Proposed Student
Accommodation, Ballybeg Drive,
Co. Waterford

Quality Audit

Stage 1 Road Safety Audit

Document Ref:	P23106-PMCE-XX-XX-RP-SA-RSA-3_ZZ_01
----------------------	--

I.2.1 Pedestrian Crossings

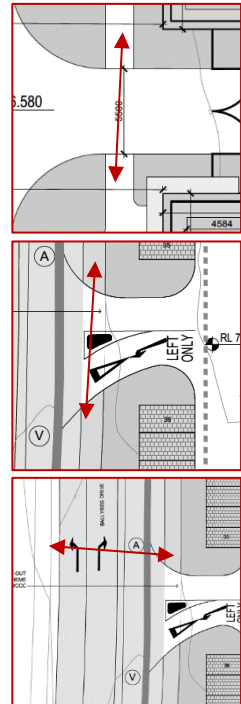
There are a number of locations within the proposed development where pedestrian crossings have not been indicated on likely pedestrian desire lines, these locations include:

1. No pedestrian crossing has been indicated across the fire tender gated access.
2. No pedestrian crossing has been indicated across the development carpark access.
3. No pedestrian crossing has been indicated across Ballybeg Drive at the location of the vehicular access to the development carpark.

An absence of pedestrian crossings on likely pedestrian desire lines may lead to pedestrians crossing the road at locations where drivers may be less attentive to them, and may restrict mobility and visually impaired pedestrians from being able to independently navigate the local road network.

Pedestrian crossings, including dropped kerbs and appropriate tactile paving, which can accommodate the expected volume of pedestrians and cyclists, should be provided on likely pedestrian desire lines and where the footpath terminates at the edge of the carriageway.

I.2.2 Connectivity between the Internal Courtyard and the Development Carpark

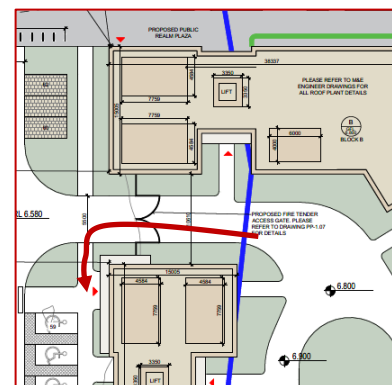
It is unclear from the drawings provided how the pedestrian routes within the internal courtyard will connect to facilities at the location of the primary access.

Should no connectivity be provided, it may lead to pedestrians and cyclists travelling along the carriageway between the development's proposed internal courtyard and the carpark access road or the grass verge adjacent the gated access.

The likely pedestrian desire lines between the proposed development's internal courtyard and the pedestrian facilities at the primary access should be identified, and measures provided to cater for these desire lines safely.

1.2.3 Connectivity to Kilbarry Nature Park

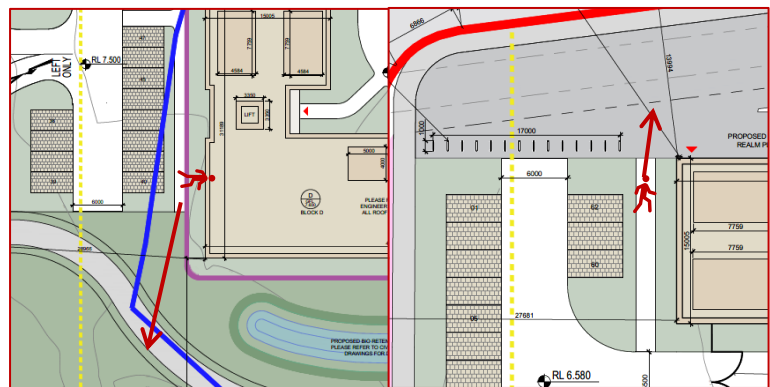
The Kilbarry Nature Park to the southeast is likely to be an attractive destination for students in the student accommodation. However, it is not clear if direct pedestrian/cycle links will be provided between the southern and eastern extents of the development and this destination, or if this pedestrian desire line will be catered for in this, or a future development phase.

The absence of this direct route may discourage pedestrians from choosing walking as a regular form of travel, as the indirect route via the Cork Road, Inner Ring Road and Tramore Road may be considered too long.

Ensure a more direct route for pedestrians is provided to the Kilbarry Nature Park.

1.2.5 Footpath/Cycle Track Layout

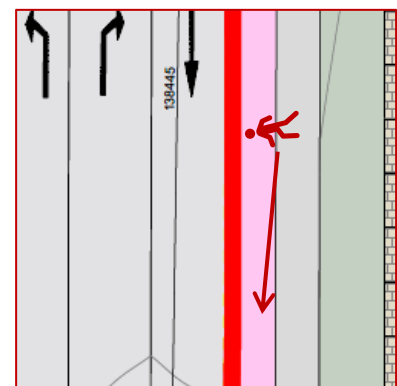
A cycle track and footpath has been indicated along both sides of Ballybeg Drive continuing to Lacken Road to the development extents. No information, however, has been provided in relation to the cross-section of the footpath/cycle track and it is, therefore, unclear if a level difference would be provided between the footpath and cycle track. The absence of a level difference may lead to visually-impaired pedestrians being insufficiently aware of the cycle track resulting in them inadvertently entering it, where there is an increased risk of being struck by a cyclist.

The footpath and cycle track should be vertically separated or appropriate tactile paving provided to advise visually-impaired pedestrians of the footpath/cycle track layout.

I.2.7 Mobility-Impaired Parking Spaces Dimensions

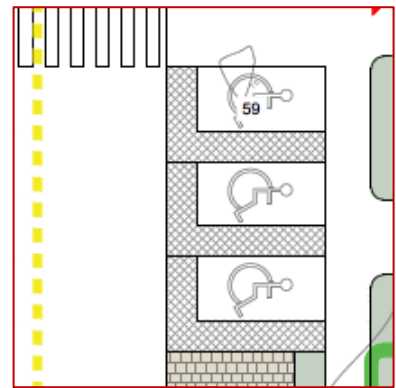
Parking space dimensions have not been provided at this early stage in the design process, so the width of parking spaces is unknown. However, the mobility parking spaces dimensions may be insufficient to accommodate mobility users getting in and out of their vehicles.

The width of mobility parking spaces should be compliant with the Traffic Signs Manual.

I.2.8 Tactile Paving Colour

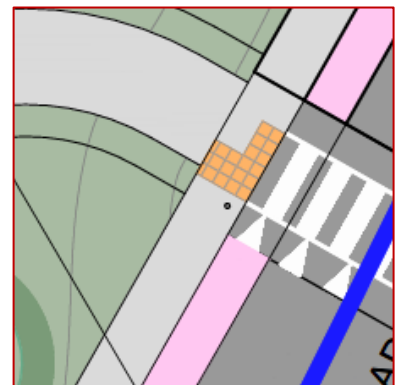
A 'Zebra' crossing is proposed across Lacken Road. The tactile paving on the western side of the crossing is not the required colour. This could lead to visually impaired pedestrians being insufficiently aware of the Zebra crossing.

Tactile paving at Zebra crossings (i.e. Controlled crossings) should be red in colour.

I.2.9 Crossing Point Missing

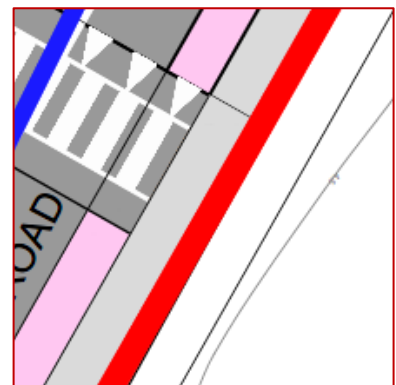
A crossing has been indicated across Lacken Road. However, dropped kerbs, and associated tactile paving, has not been indicated at the corresponding crossing point on the other side of Lacken Road.

Dropped kerbs, and associated tactile paving should be provided at the eastern side of the Zebra crossing across Lacken Road aligned towards the opposing crossing point.

I.2.10 Inter-visibility between Road Users

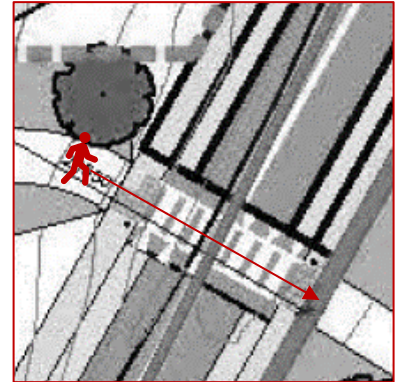
Inter-visibility between drivers and pedestrians waiting to cross at the Zebra crossing across Lacken Road may be restricted by trees located adjacent to the crossing.

Should inter-visibility between drivers and pedestrians (or cyclists) waiting at, or using, the crossing be restricted, there is a risk of drivers failing to stop.

Sufficient inter-visibility between drivers and VRUs should be provided at crossings within the proposed development.

I.2.11 Overhanging trees/vegetation along the 'green link' path

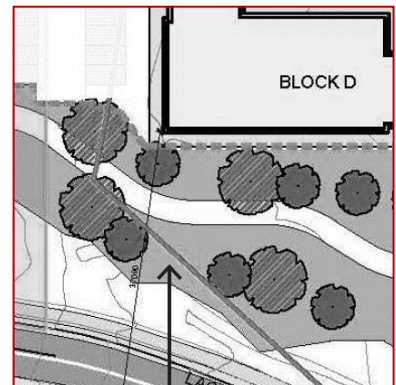
A number of trees have been indicated adjacent to the proposed 'green link' path which may obstruct pedestrian/cyclist movement.

Ensure new tree canopies or other items of roadside furniture do not present obstacles/hazards to pedestrians or cyclists.

I.2.12 Verge at Set- Down and Parking Spaces Area

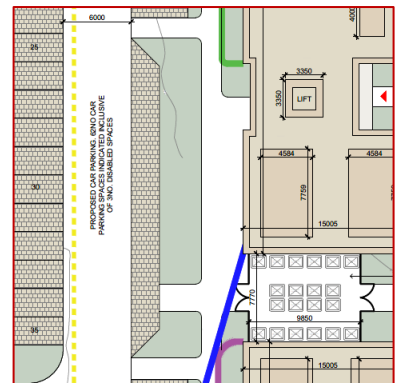
A verge has been indicated between the footpath and set-down area opposite block D. It is not clear what this verge would be comprised of (e.g. grass, planting, hardstand, etc). Should it include a grass verge or planting, it may restrict movement of vehicle occupants between the set-down area and the footpath.

Additionally, no footpath has been provided to the rear of most of the parking spaces.

A paved connection between the footpath and set-down area and at the rear of parking spaces should be provided.

I.2.13 Lack of Edge Protection

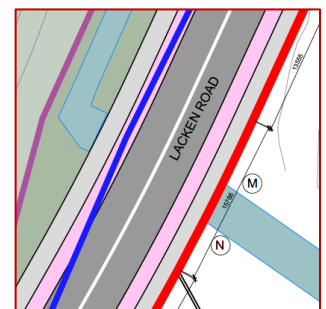
A stream is indicated along the northern boundary of the development and then diverts to the south adjacent to the eastern boundary. Additionally, it is proposed to provide two attenuation ponds at either side of the 'green link' path south of the proposed student accommodation. At this early stage in the design, edge protection, or buoyancy aids have not been indicated at the rear of the footpath where the footpath crosses the watercourse. This could lead to inattentive pedestrians descending into the watercourse below.

Ensure sufficient edge protection, and buoyancy aids, are provided at crossings of the stream and near attenuation ponds, ensuring it is clearly visible during the hours of darkness.

I.2.14 Carpark Crossing Details

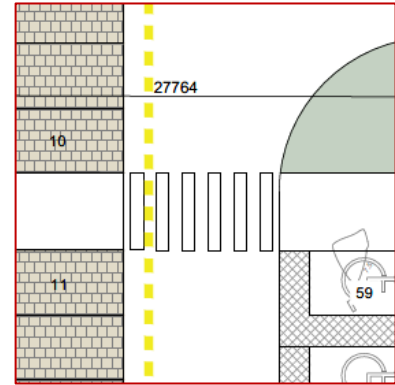
It is assumed that the NMU routes within the proposed development are delineated from the adjacent carriageway within the carpark by a physical kerb. A dropped kerb and tactile paving have not been indicated at the pedestrian crossing within the carpark. A failure to provide a dropped kerb at crossings and at the end of NMU routes may lead to mobility impaired pedestrians experiencing difficulties descending/ascending the kerb at this location or being insufficiently aware that they are in an area shared with vehicles.

Dropped kerbs and tactile paving should be provided at the pedestrian crossing in the carpark and at locations where NMU routes exit onto shared surfaces or other areas shared with other road users.

I.2.15 Layout of Pedestrian and Cycle Facilities at the Ballybeg Drive Crossing

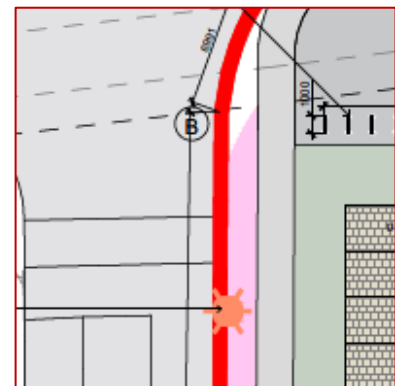
An existing controlled crossing is provided at the southern arm of the Ballybeg Drive/ Cork Road junction. Segregated pedestrian and cycle facilities appear to be indicated on the eastern side of the crossing while a footpath only is indicated on its western side. It is therefore unclear how it is intended for cyclists to access these facilities and if pedestrians, or cyclists, would be required to cross the adjacent facility to access the footpath/cycle track.

A shared surface should be provided on both sides of the crossing with the segregated footpath and cycle track on the eastern side commencing to the south of the crossing with a suitable transition provided between the shared and segregated facilities.

II.2.2 Connectivity between the Internal Courtyard and the Development Carpark

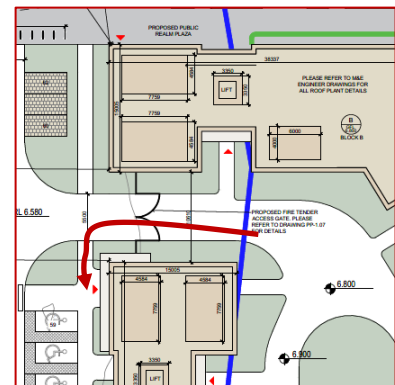
It is unclear from the drawings provided how the pedestrian routes within the internal courtyard will connect to facilities at the location of the primary access.

Should no connectivity be provided, it may lead to pedestrians and cyclists travelling along the carriageway between the development's proposed internal courtyard and the carpark access road or the grass verge adjacent the gated access.

The likely pedestrian desire lines between the proposed development's internal courtyard and the pedestrian facilities at the primary access should be identified, and measures provided to cater for these desire lines safely.

II.2.3 Connectivity to Kilbarry Nature Park

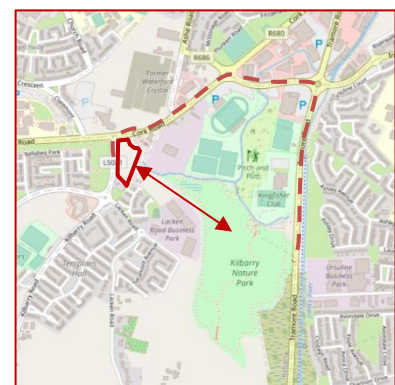
The Kilbarry Nature Park to the southeast is likely to be an attractive destination for students in the student accommodation. However, it is not clear if direct pedestrian/cycle links will be provided between the southern and eastern extents of the development and this destination, or if this pedestrian desire line will be catered for in this, or a future development phase.

The absence of this direct route may discourage pedestrians from choosing walking as a regular form of travel, as the indirect route via the Cork Road, Inner Ring Road and Tramore Road may be considered too long.

Ensure a more direct route for pedestrians is provided to the Kilbarry Nature Park.

II.2.4 Pedestrian Desire Lines

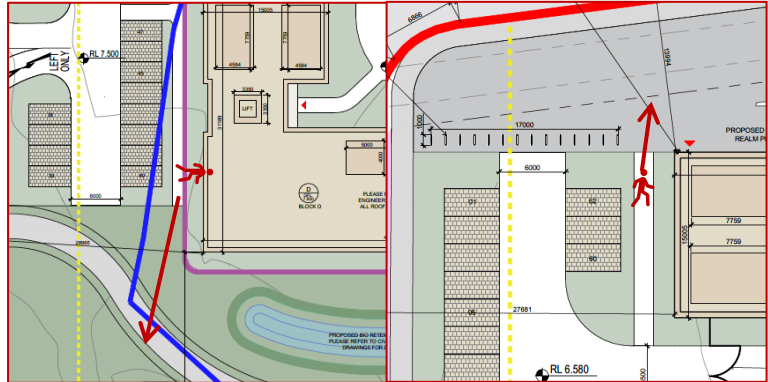
The 'Green link' path runs along the southern side of the proposed student accommodation connecting the eastern footpath of Ballybeg Drive with the northern footpath of Lacken Road. The proximity of the development carpark to the green link may create a pedestrian desire line between these locations, however, no connection for pedestrians has been provided.

Similarly, a public plaza is indicated to the north of the development, however, no direct pedestrian link is provided between the development carpark and the plaza.

Measures should be provided to facilitate pedestrian movements along pedestrian desire lines.

IV.2.1 Crossing Overshoot

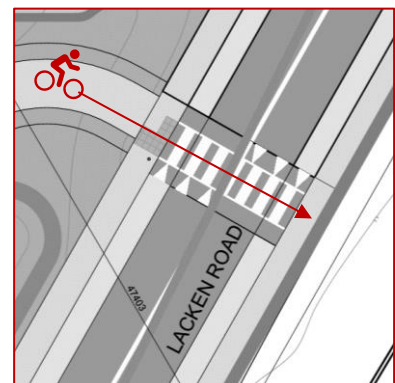
A 'Zebra crossing' is provided at the southeastern end of the 'green link' path between Ballybeg Drive and Lacken Road, which is likely to be used by cyclists. Cyclists should dismount at the end of the footpath on the northern side of Lacken Road and cross the 'Zebra' crossing on foot. However, user behaviour may see cyclists continuing on their bicycle to cross to the southern side of Lacken Road. This could result in cyclists approaching, and continuing through, the crossing at speed, leading to sudden entry to the carriageway.

This problem may be exacerbated by the increasing use of electric bicycles and E-scooters.

Measures should be provided to encourage cyclists to slow on approach.

IV.2.2 Layout of Pedestrian and Cycle Facilities at the Ballybeg Drive Crossing

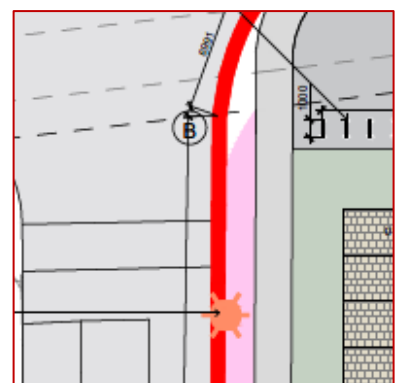
An existing controlled crossing is provided at the southern arm of the Ballybeg Drive/ Cork Road junction. Segregated pedestrian and cycle facilities appear to be indicated on the eastern side of the crossing while a footpath only is indicated on its western side.

It is therefore unclear how it is intended for cyclists to access these facilities and if pedestrians, or cyclists, would be required to cross the adjacent facility to access the footpath/cycle track.

A shared surface should be provided on both sides of the crossing with the segregated footpath and cycle track on the eastern side commencing to the south of the crossing with a suitable transition provided between the shared and segregated facilities.

IV.2.3 Tie- in with Existing Facilities

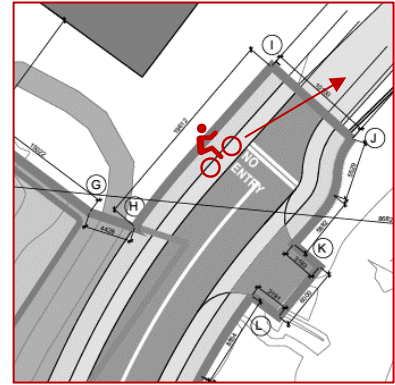
The absence of safe vertical and horizontal transitions could lead to confusion and abrupt route changes for cyclists transitioning between the new and old cross sections.

Transitions to existing facilities should be introduced at Lacken Road to support expected cyclists routes.

IV.2.4 Cyclist Crossing Facilities to/from Bicycle Stand at Public Plaza

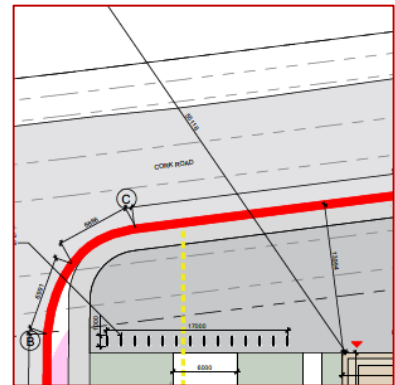
Existing pedestrian crossings and facilities are provided at the junction between Ballybeg Drive and Cork Road. However, no facilities have been indicated for cyclists travelling to/from the bicycle parking area on the public plaza and the existing advisory cycle lane to the north of Cork Road.

This may lead cyclists using the existing pedestrian crossing and mounting/dismounting a full height kerb to cross the carriageway where there is a risk of falls from their bicycle

Facilities for cyclists should be provided to travel to/from the bicycle parking spaces at public plaza and the advisory cycle lane on Cork Road.

IV.2.5 Overhanging trees/vegetation along the 'green link' path

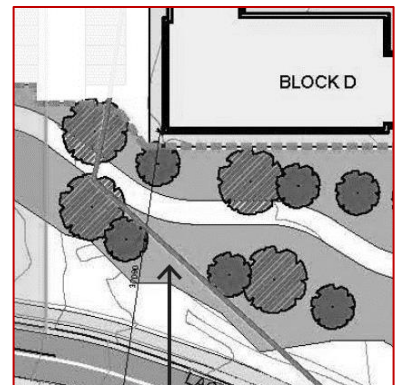
A number of trees have been indicated adjacent to the proposed 'green link' path which may obstruct pedestrian/cyclist movement.

Ensure new trees canopies or other items of roadside furniture do not present obstacles/hazards to pedestrians or cyclists.

4.3 Pedestrian Crossing of Development Access

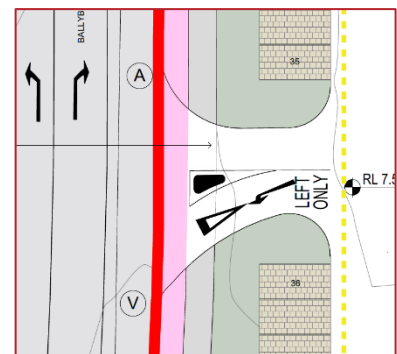
Summary: A pedestrian crossing has not been indicated across the proposed development access and it is unclear if the splitter island between the left-in and left-out lanes will be large enough to accommodate pedestrians who cannot complete a crossing in one movement.

A left-in left-out junction has been indicated at the access to the proposed development on Ballybeg Drive. No pedestrian crossing has been indicated across the access. A failure to provide a crossing with dropped kerbs would lead to pedestrians having to ascend/descend a full height kerb on both sides when crossing the access. This could lead to difficulties for pedestrians, particularly the mobility-impaired, when crossing the access resulting in an increased risk of trips and falls.

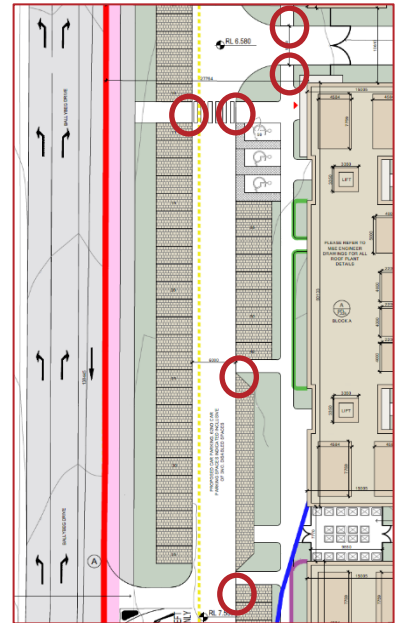
Summary: The internal footpath network within the proposed development terminates at the carriageway at a number of locations with no opposing crossing location, and tactile paving has not been indicated at locations where pedestrian crossings have been indicated.

The footpaths within the proposed development are indicated as terminating at the carriageway at a number of locations where no downstream/opposing crossing point has been indicated. It is assumed that these are intended for access for vehicle occupants however, should only dropped kerbs be provided at these locations, there is a risk that a visually-impaired pedestrian may inadvertently continue into the carriageway where there is an increased risk of being struck by a vehicle.

In addition, where footpaths are indicated as terminating at the edge of the carriageway opposite opposing footpaths, which are assumed to be pedestrian crossings, no dropped kerbs and tactile paving have been indicated. A failure to provide tactile paving at pedestrian crossing locations may lead to visually-impaired pedestrians inadvertently entering the carriageway and being struck by a vehicle.

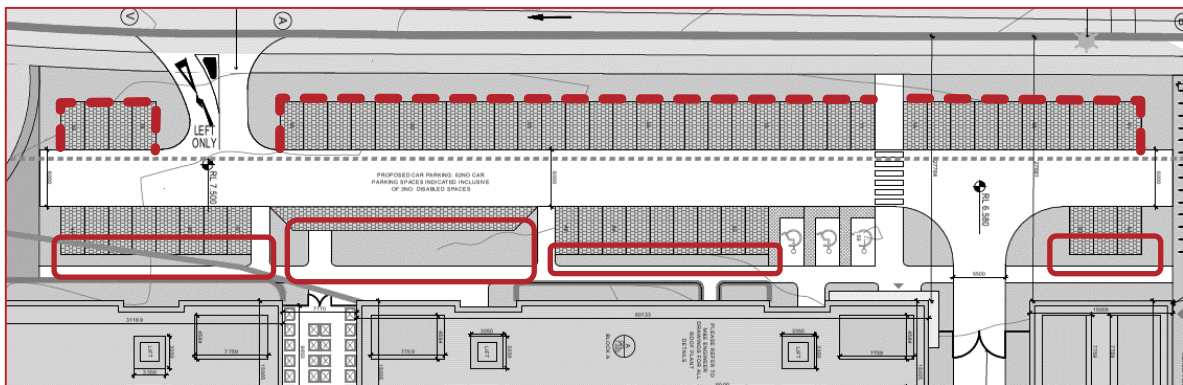
Summary: Footpaths have not been indicated directly adjacent to parking spaces and the set-down area within the proposed development which may lead to vehicle occupants travelling within the carriageway, or verge, to reach a footpath.

Footpaths have not been indicated adjacent to parking spaces, and the set-down area, within the proposed development. This would require vehicle occupants to travel between the accommodation building and their vehicle within the carriageway where there is an increased risk of being struck by a vehicle, or within/through the verge to a suitable pedestrian crossing/footpath where there is a risk of slips and falls, particularly during wet or icy weather.

In addition to providing a footpath at parking spaces no. 36 – 39, a pedestrian crossing should be provided to link these parking spaces to the proposed footpath on the opposite side of the carriageway.

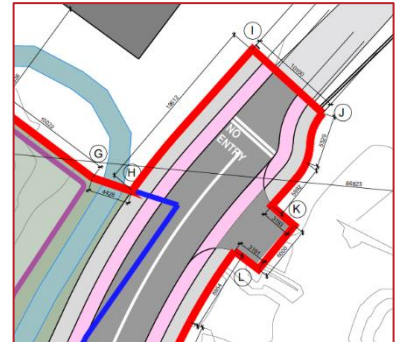
Summary: The proposed road layout at the transition between the two-way and one-way sections of Lacken Road may not be sufficient to advise northbound drivers of the restrictions at this location.

It is proposed to relocate the exit from the one-way section on Lacken Road further north and extend the two-way section to this location, providing a new access to the Kilbarry Civic Amenity Site adjacent to this transition. The centreline on Lacken Road is indicated as extending as far as the 'No Entry' road markings at the exit from the one-way section. Terminating the centreline at this location may lead to drivers misinterpreting the road layout and, should they use the centreline as a guide, continuing into the one-way section where there is a risk of head-on collisions with southbound vehicles.

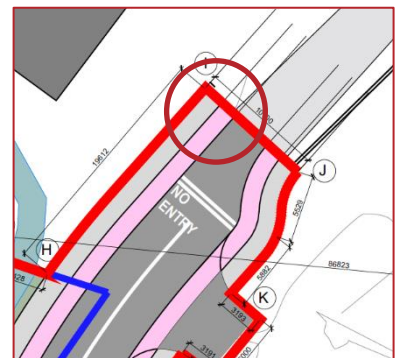
Summary: Northbound cyclists are directed into the path of oncoming southbound vehicles at its termination on Lacken Road.

It is proposed to upgrade the existing road layout on Lacken Road which would include the provision of cycle tracks/lanes on both sides of the road. The northbound cycle track/lane is indicated as continuing north of the 'No Entry' road markings at the transition between the one-way and two-way sections before terminating downstream of this location. The Audit Team acknowledge that it is proposed to upgrade the section of Lacken Road to the north of this location as part of a separate scheme however, should this development and these upgrades be implemented prior to the upgrades further north on Lacken Road, this would lead to northbound cyclists being directed to enter the carriageway within the one-way section where traffic travels in a north-to-south direction, increasing the risk of head-on collisions with southbound vehicles.
